ADDENDUM NO. 2

PACIFIC HIGH SCHOOL – NEW ADMINISTRATION BUILDING

SAN BERNARDINO CITY UNIFIED SCHOOL DISTRICT

DSA No. 04-119637 File No. 36-H7 RCA Job No. 1-78-28

MECHANICAL ENLARGED FLOOR PLAN - EAST

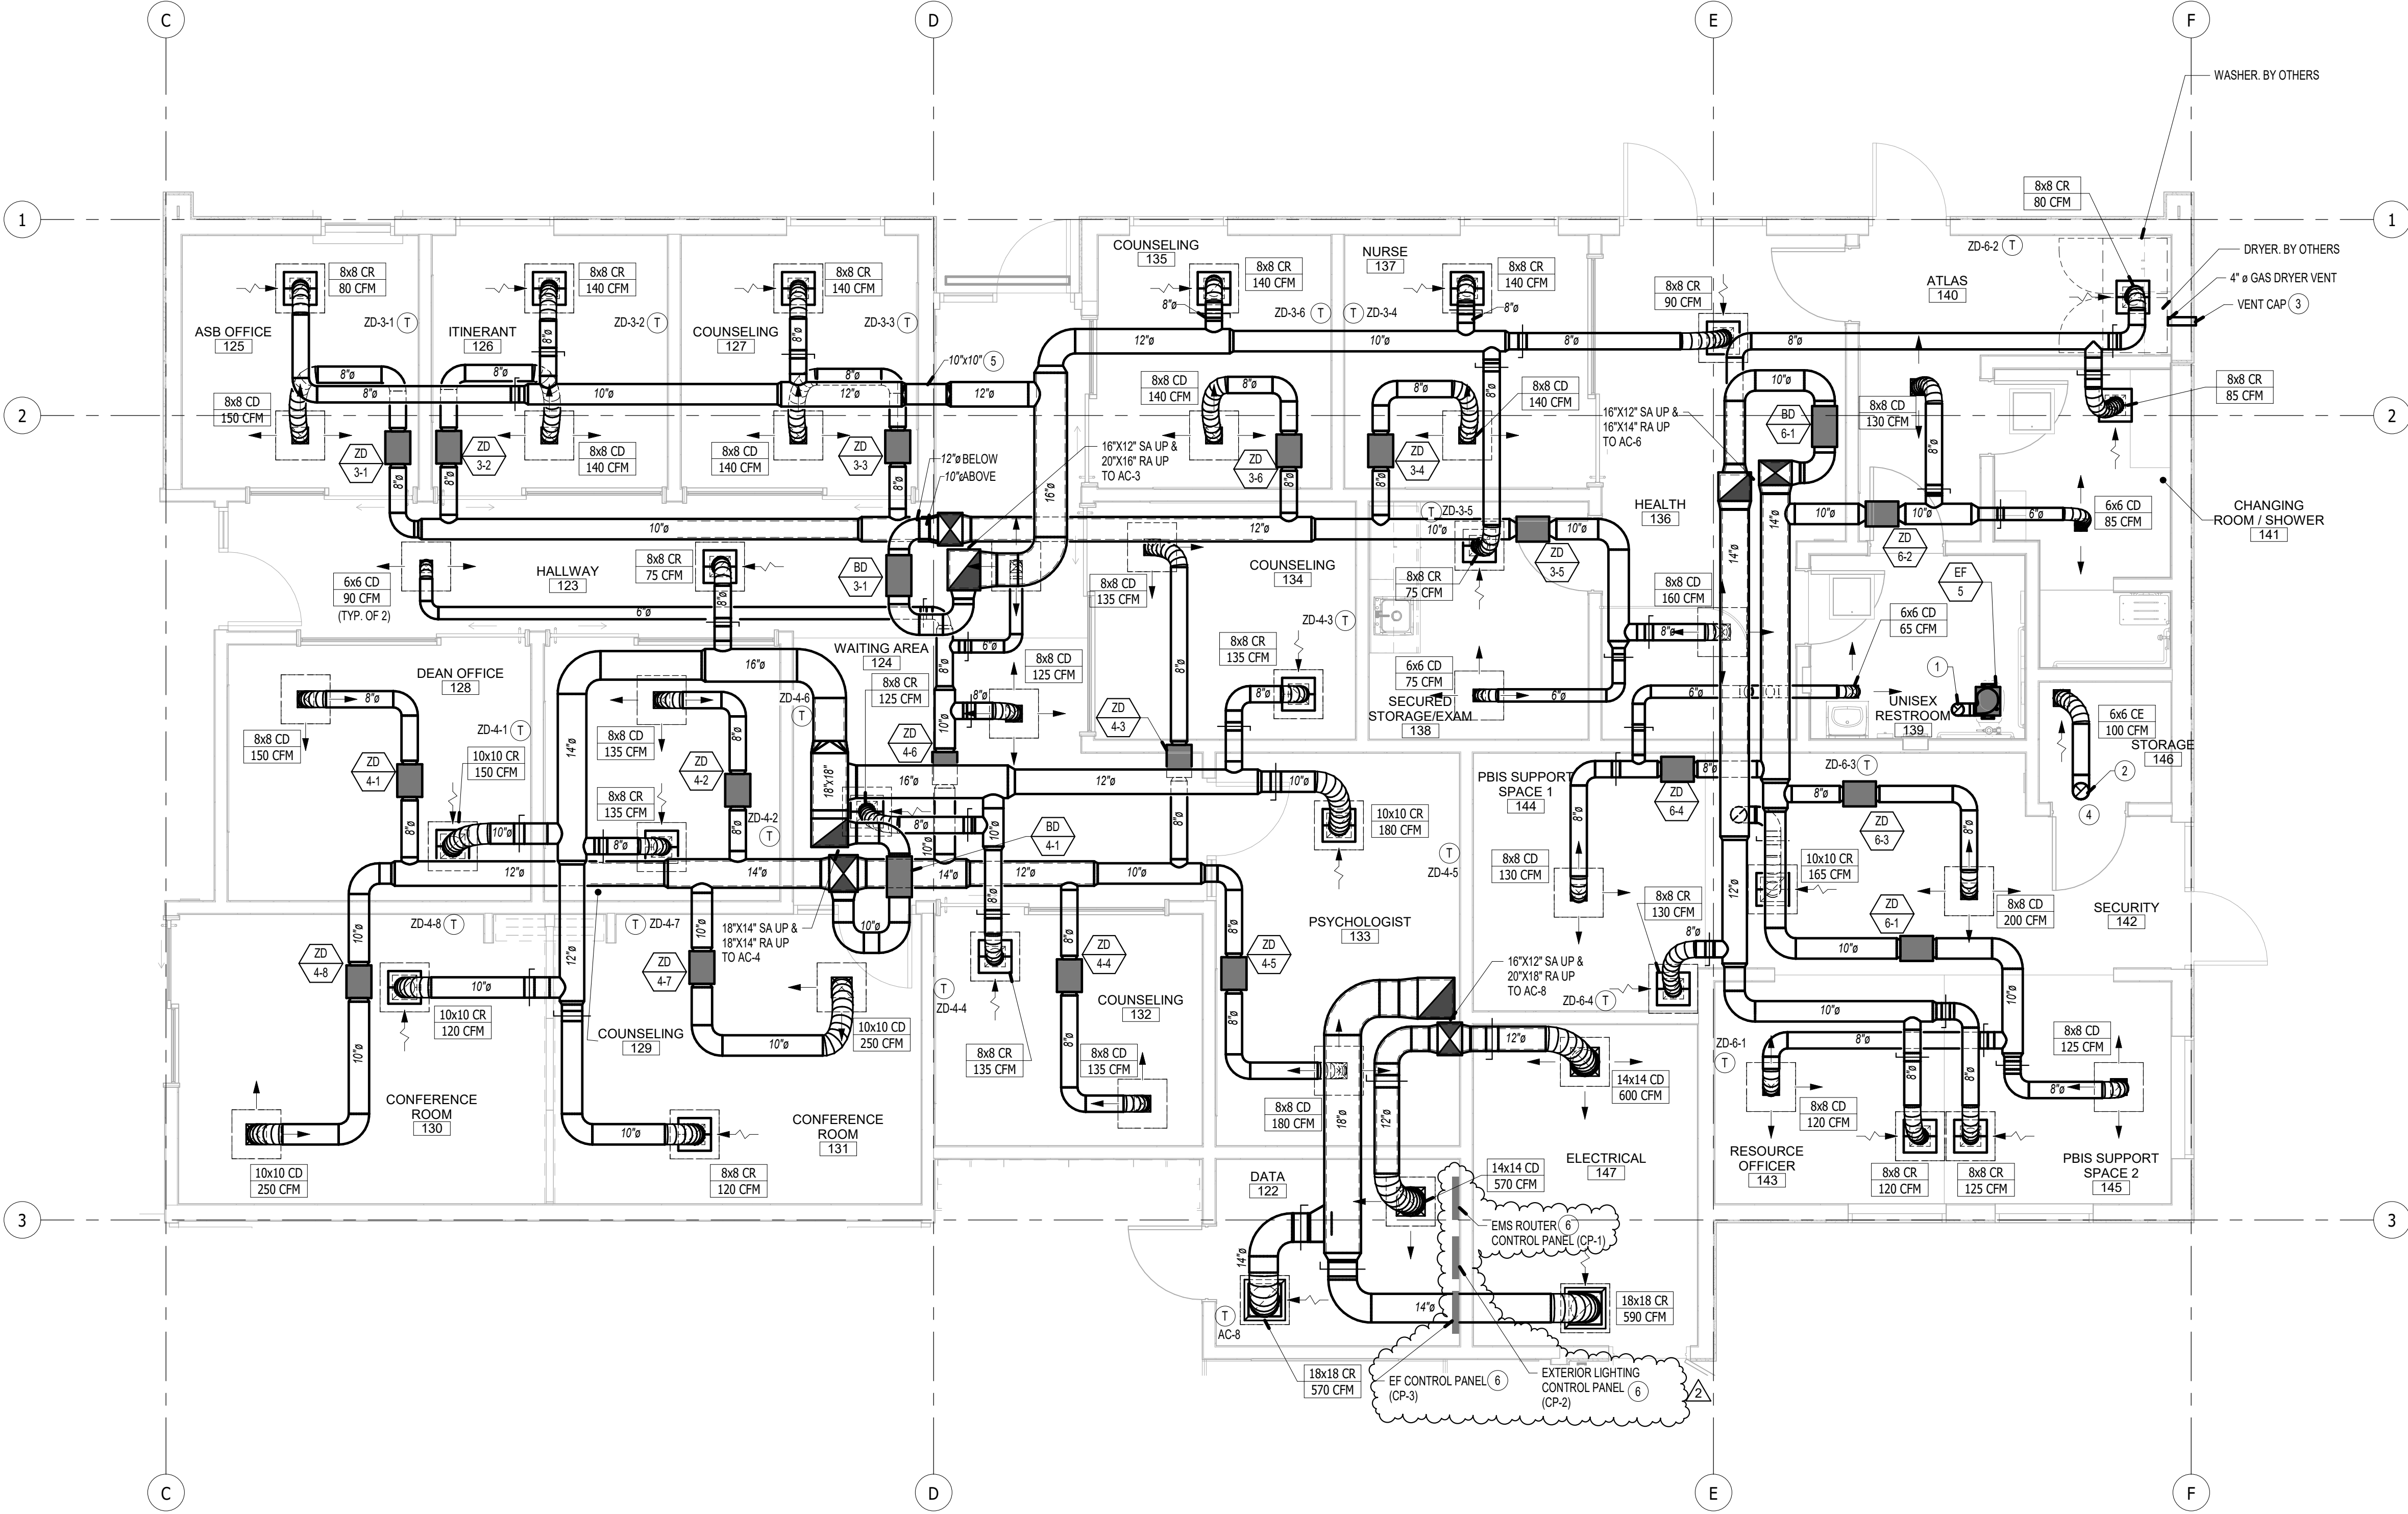
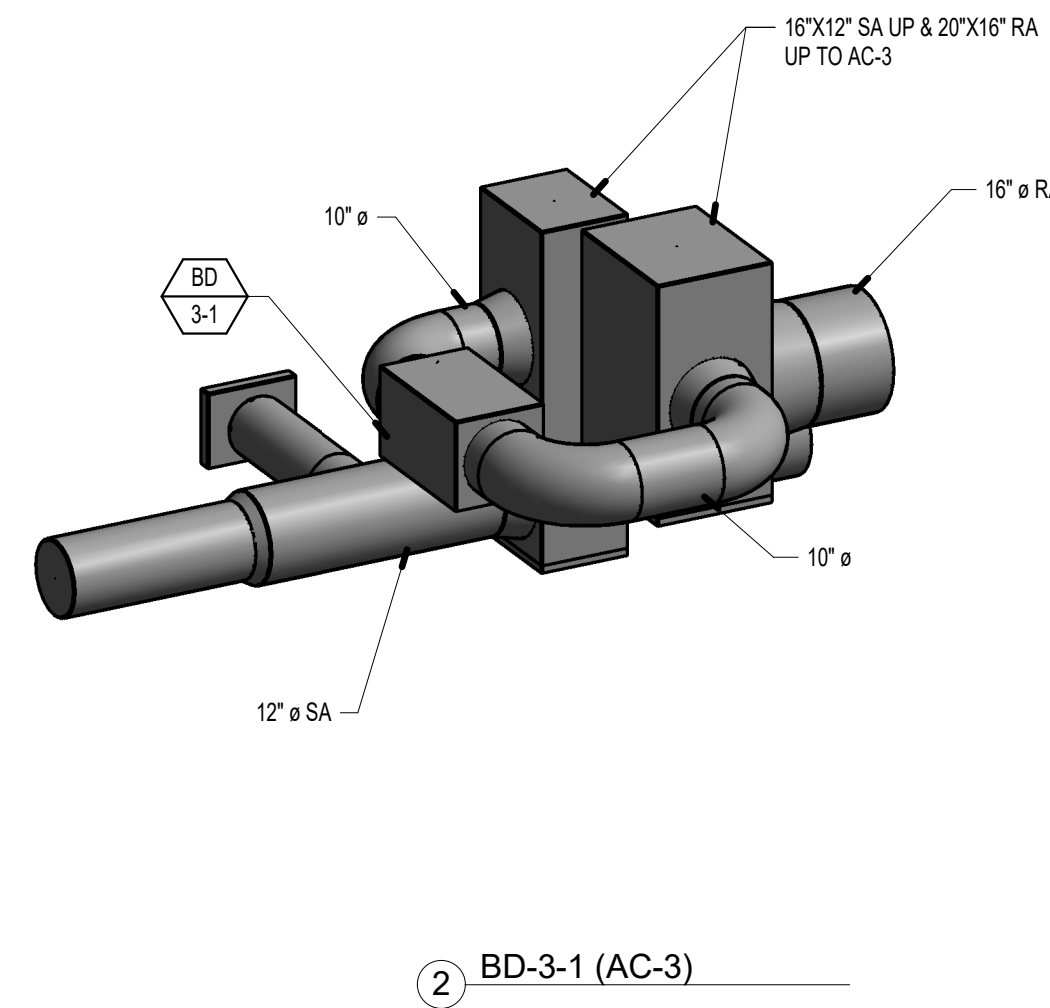
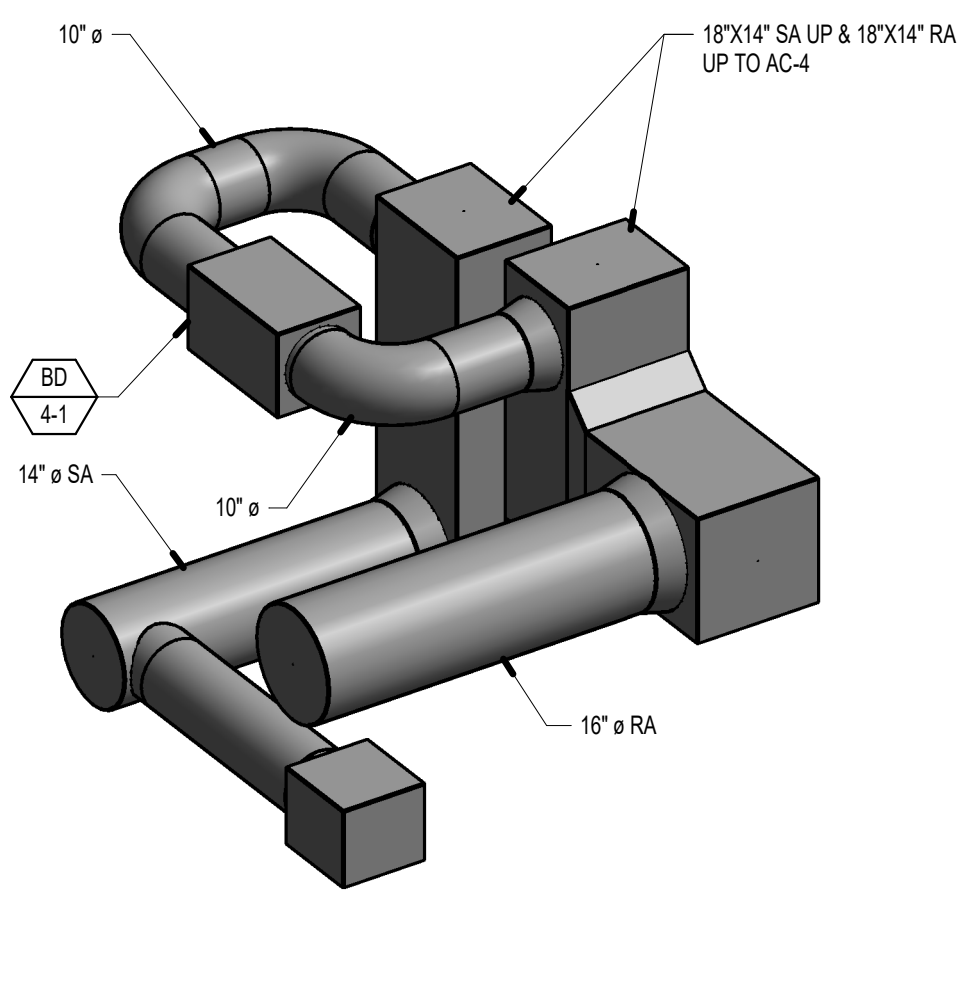
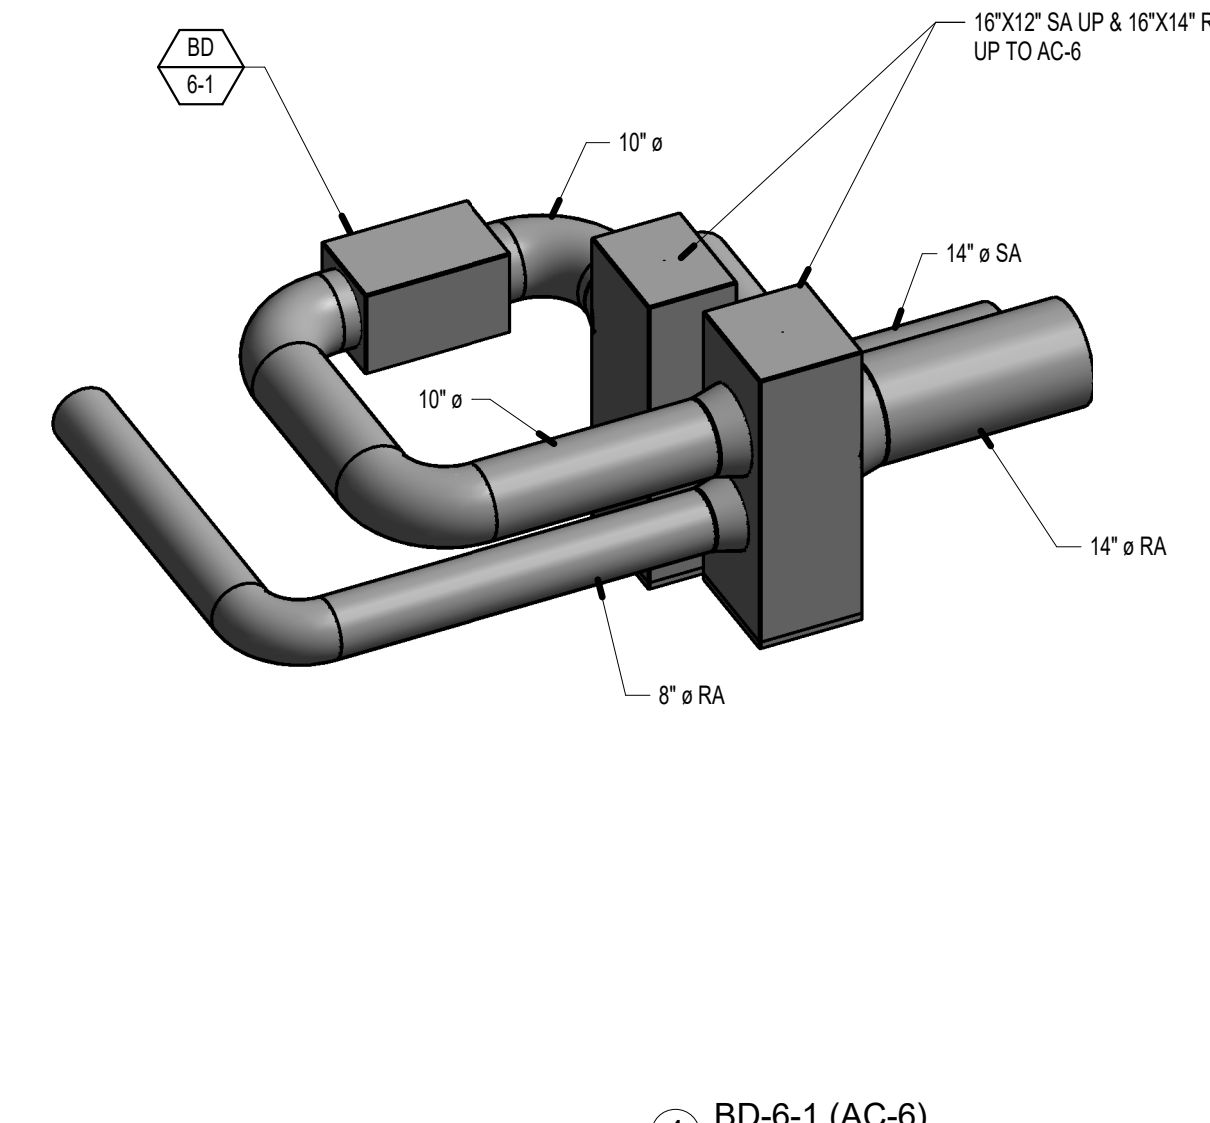
- a. Added construction note #6.
 - b. Located control panel (CP-4) for hot water circulating pump in Cust. 119.
- Item No. 2.14 Reference Sheet M-1.3:
 - 2.14.1 Revise per clouded areas of attached revised Sheet M-1.3:
